BLACK HAWK MARSH  
GAME ROAD MAINTENANCE  
SAC COUNTY, IOWA  
PROJECT NUMBER: 21-01-81-02

December 4, 2020

This Addendum is issued to modify, explain or correct the original Drawings and Specifications, and is hereby made a part of the Contract Documents. Please attach this Addendum to the Project Manual in your possession. Insert the number and issue date of this Addendum in the blank space provided on the Proposal Form.

**B.01**

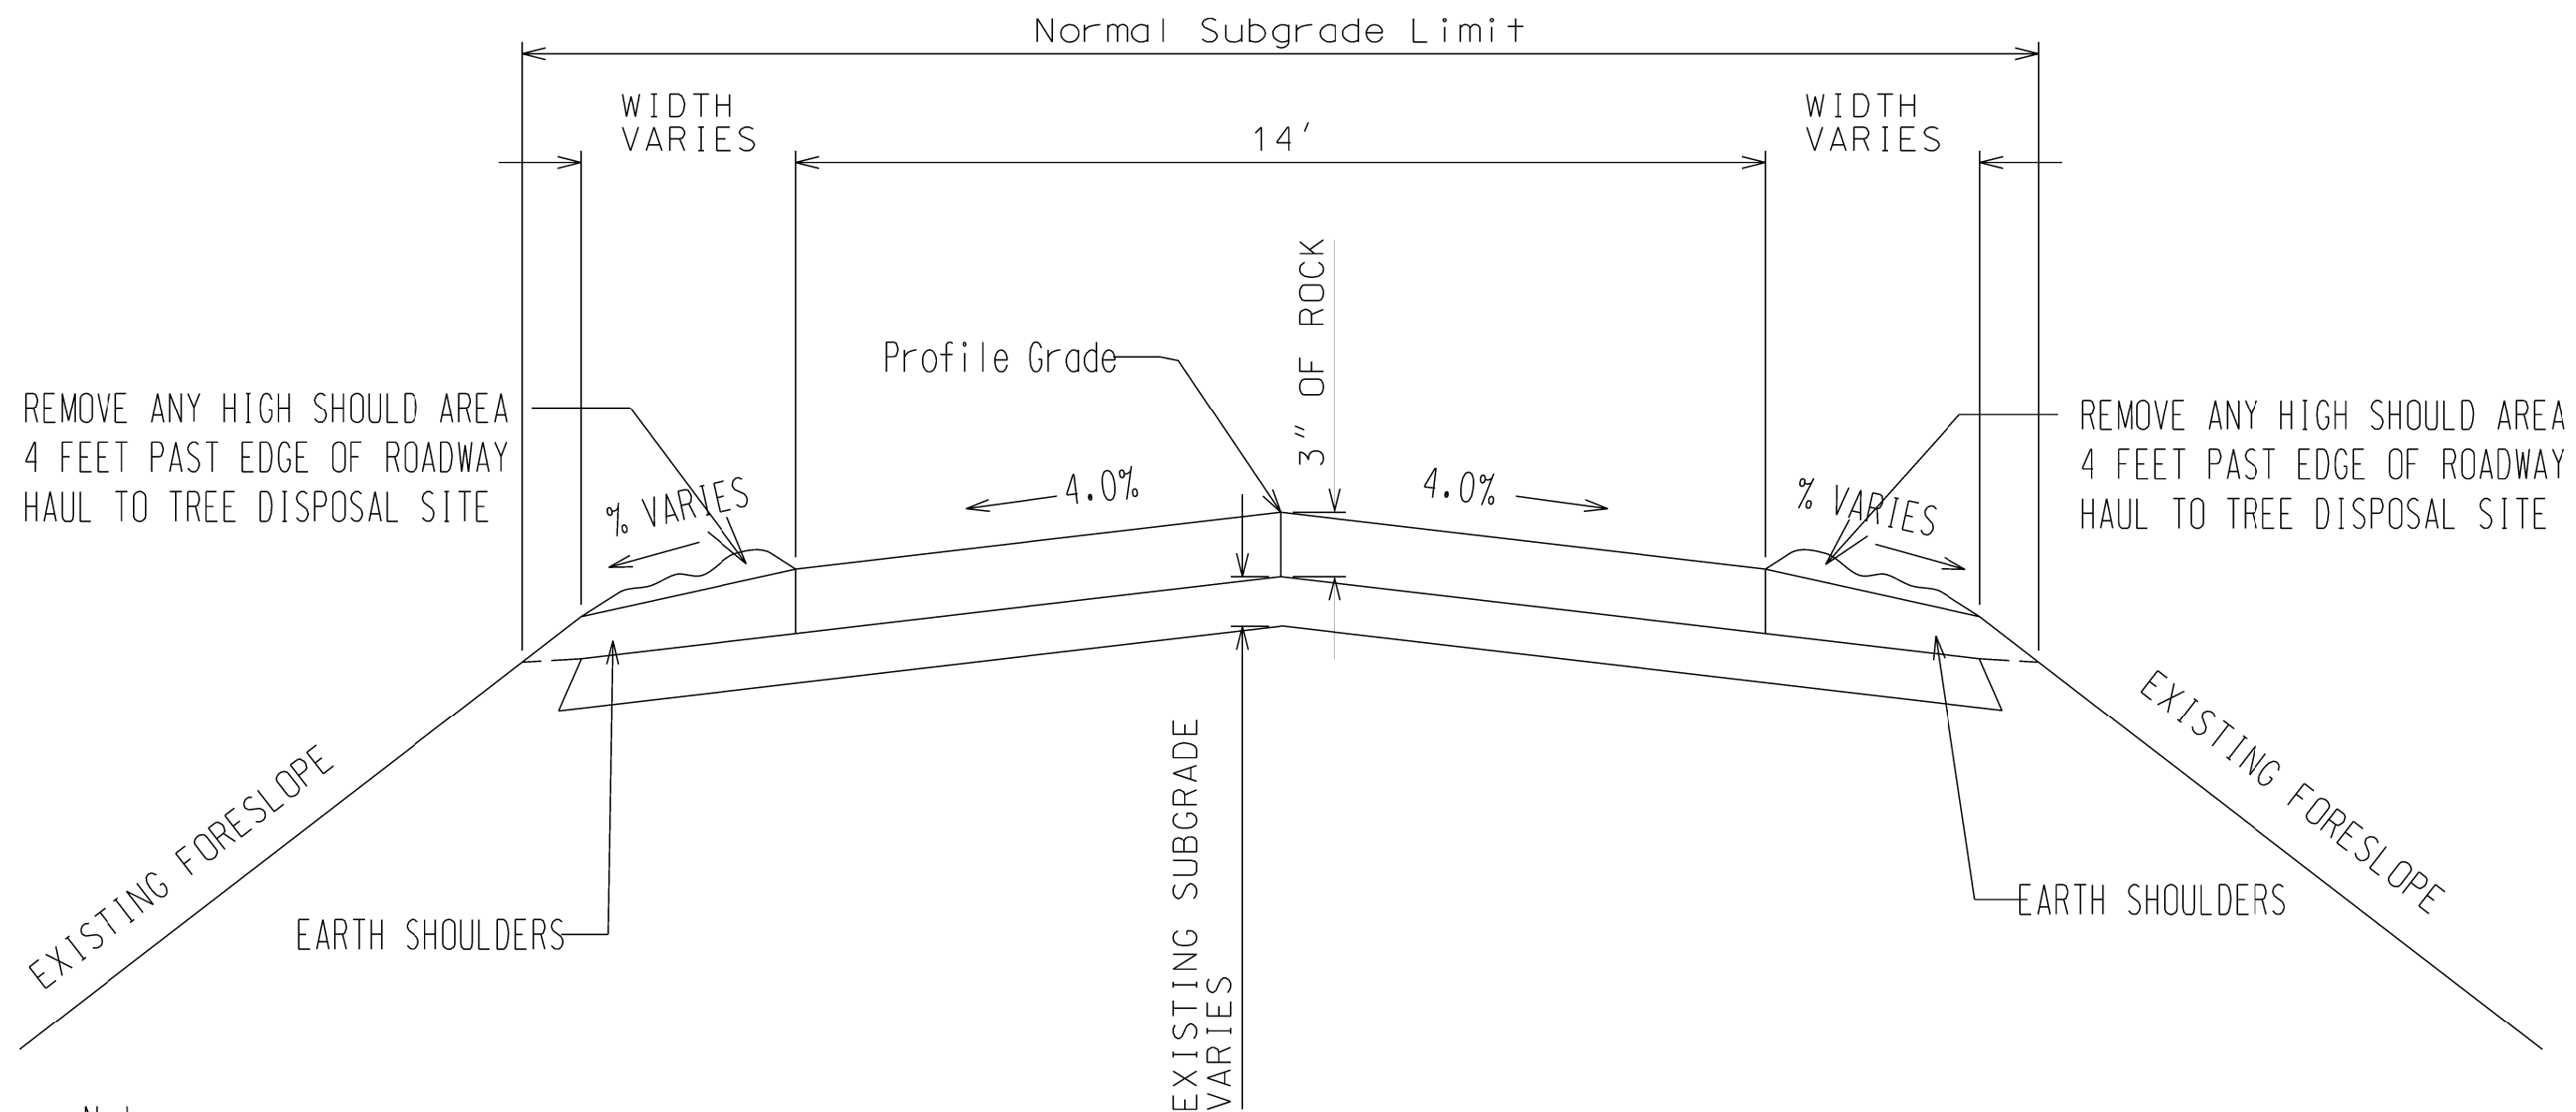
1. Sheet A.01 - Add D.05 SITE PLAN to the SHEET INDEX.  
Use the attached A.01 sheet.
2. Sheet B.01 – “Typical Roadway Section – Center Crown” – “2” OF ROCK” has been changed to “3” OF ROCK”  
Use the attached B.01 sheet.

Sheet B.01 – “REMOVE ANY HIGH SHOULD AREA 4 FEET PAST EDGE OF ROADWAY” – “REMOVE ANY HIGH SHOULD AREA 4 FEET PAST EDGE OF ROADWAY HAUL TO TREE DISPOSAL SITE”  
Use the attached B.01 sheet.
